CHATHAM AREA TRANSIT AUTHORITY IFB 2024-06, ADDENDUM NO. 1

PROJECT: CAT Hybrid Ferry Vessels

Questions posed during initial Q&A Period and CAT's Responses:

END OF ADDENDUM NO. 1

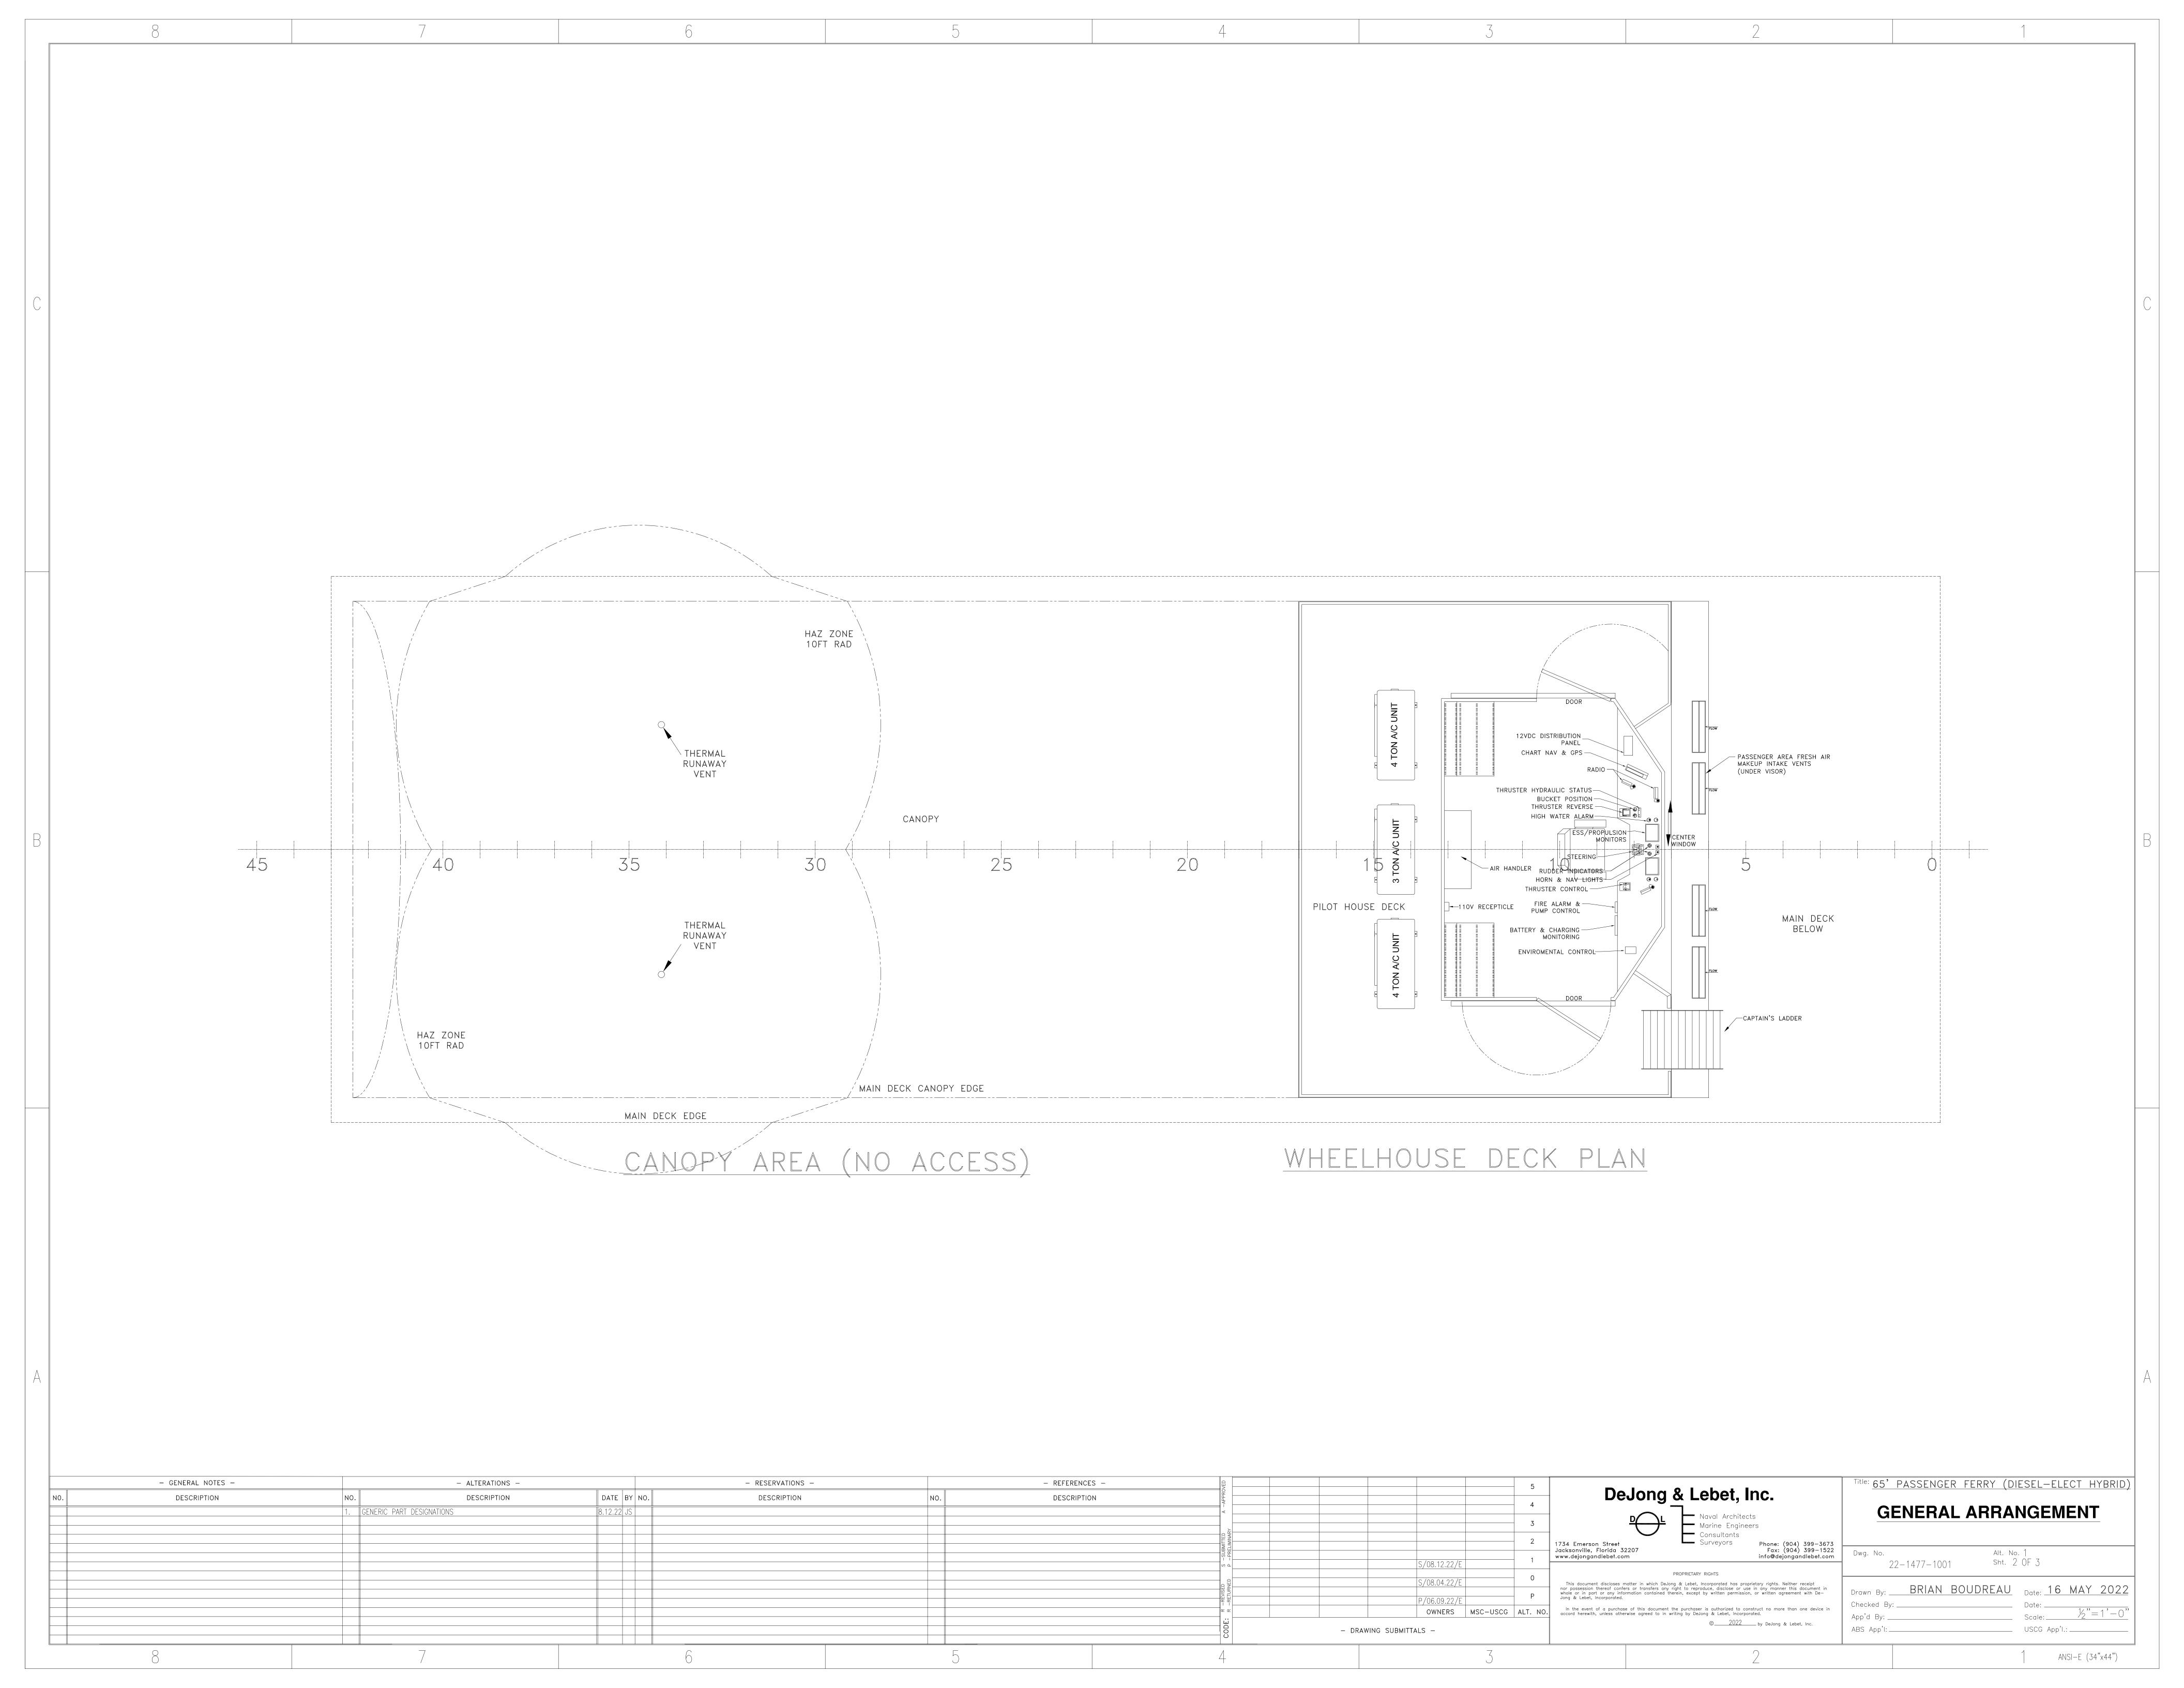
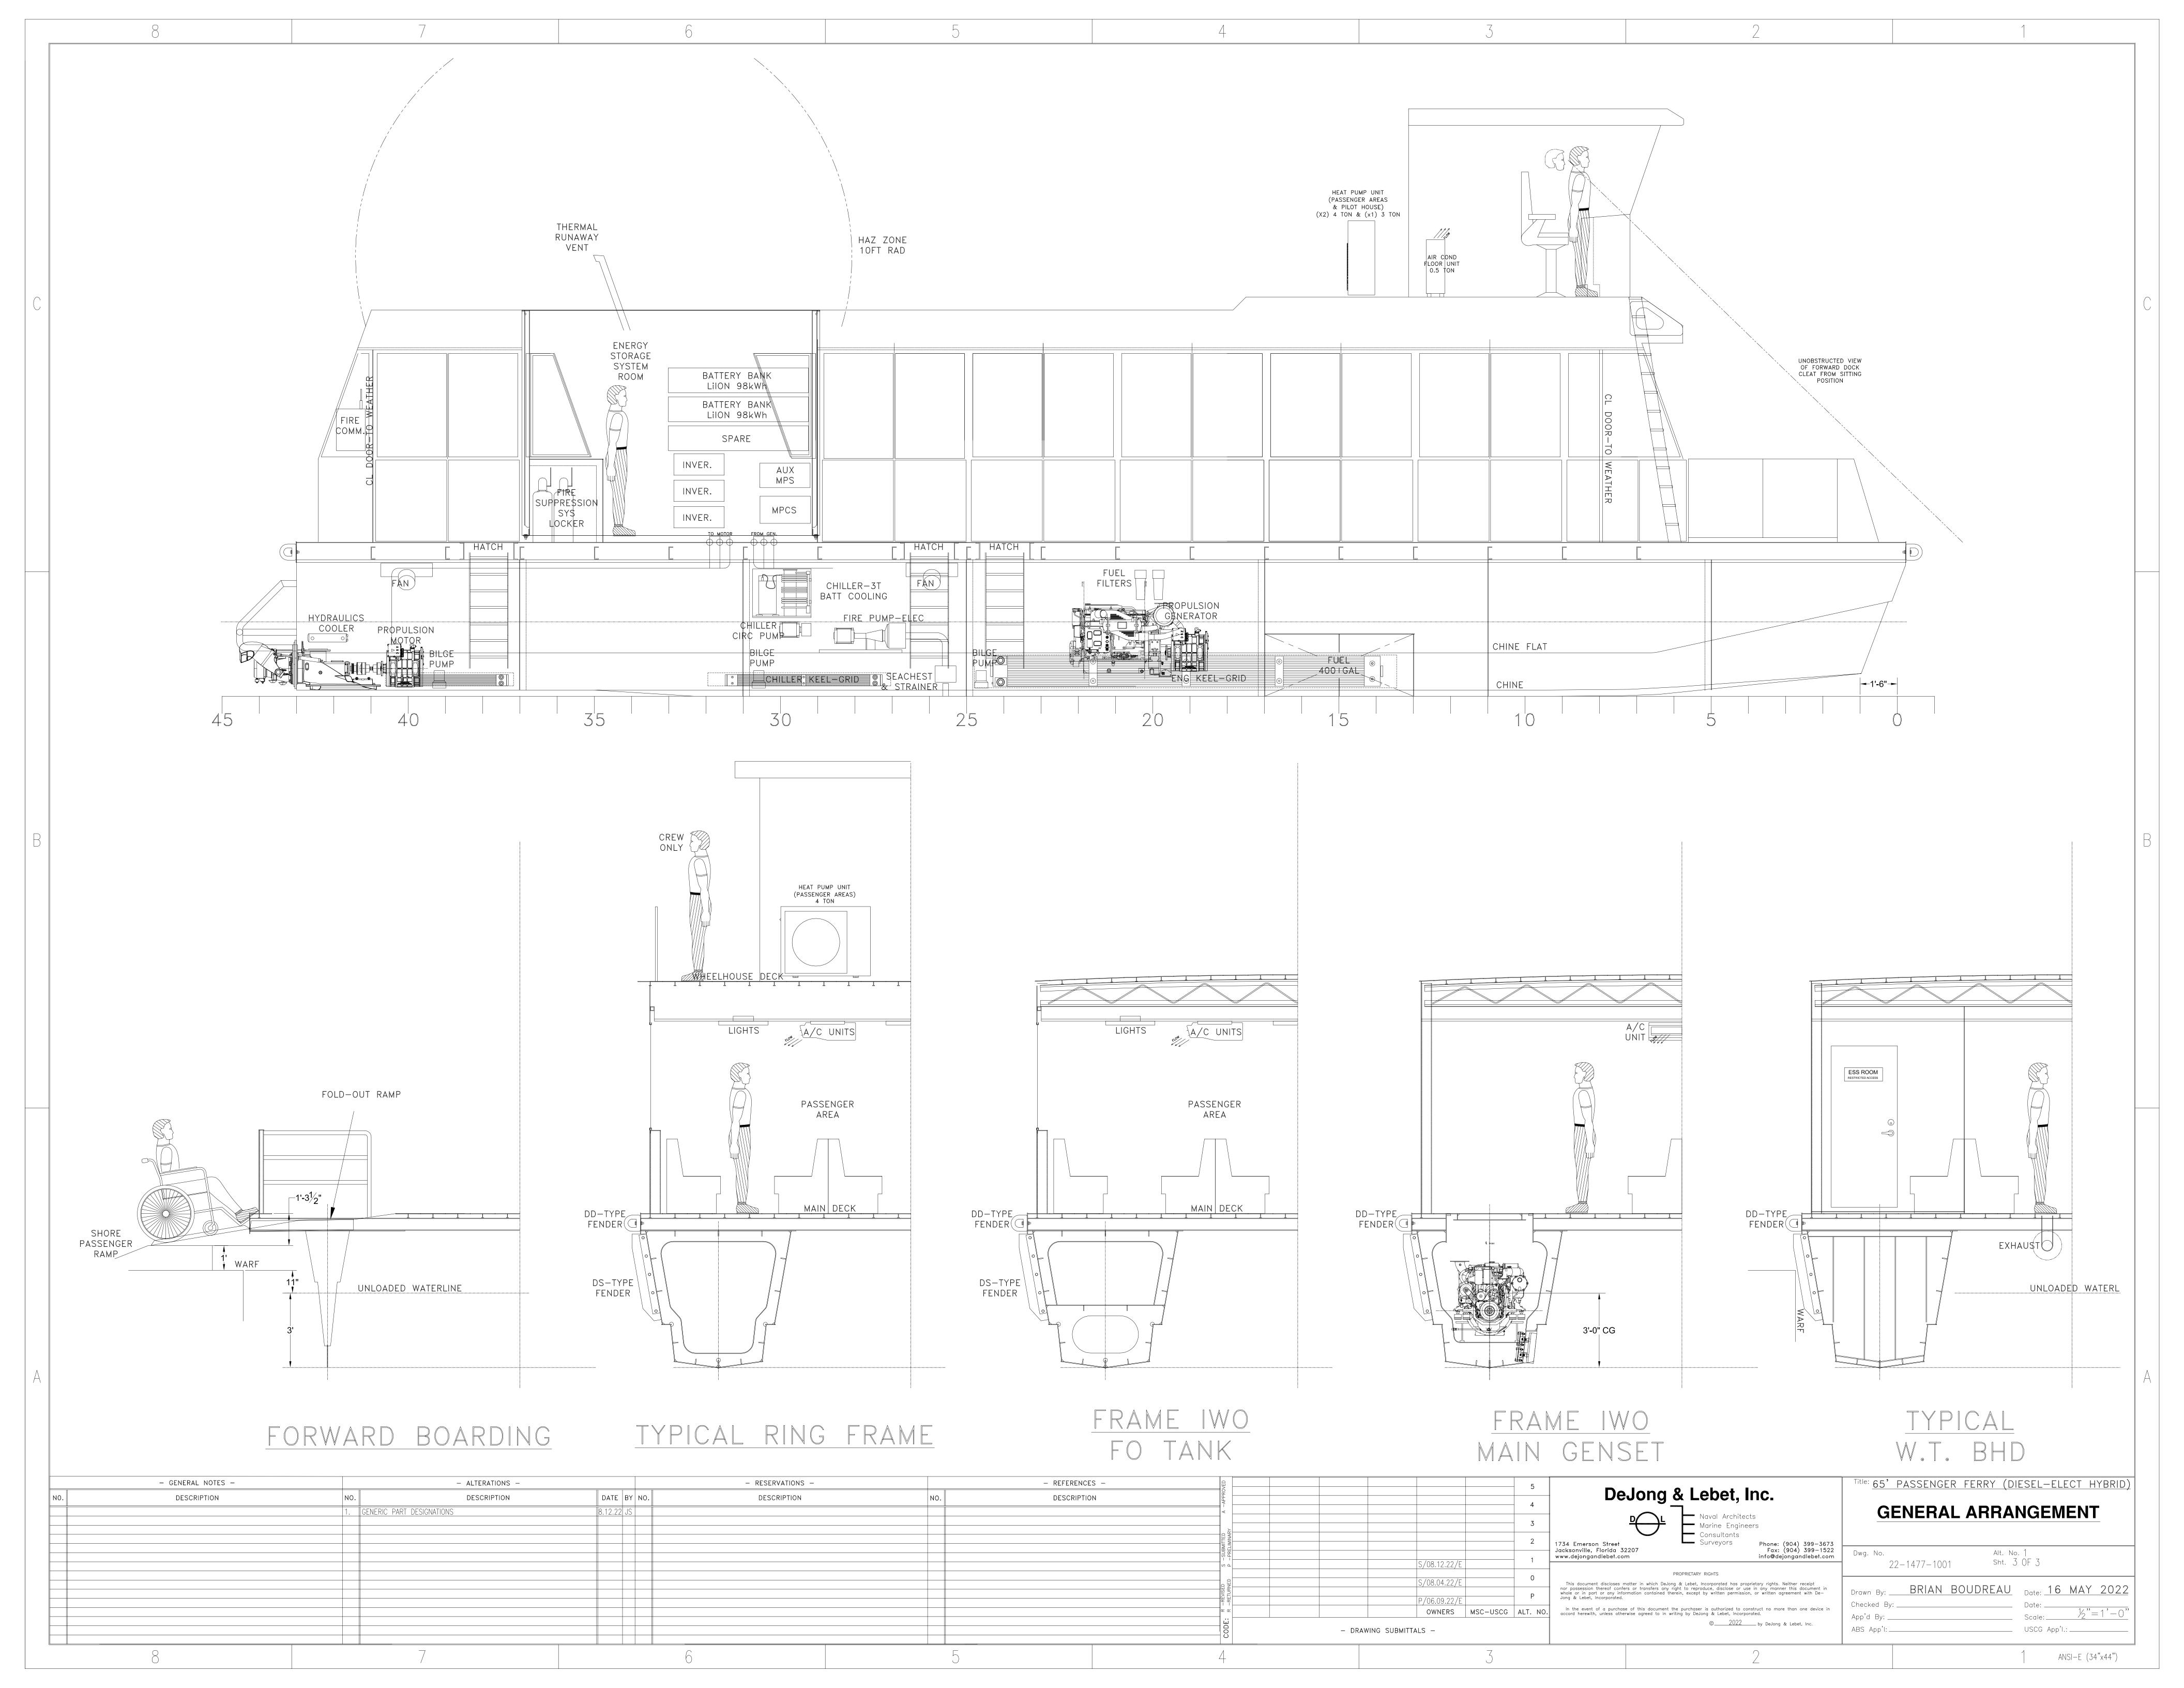
Question 9: Can you please provide me with Dwg. #22-1477-5001 & 5002 that is referenced

in the outline specifications for the 65'X21'-4" Passenger Vessel.

Response: See Plans attached #22-1477-5000 - 5002.
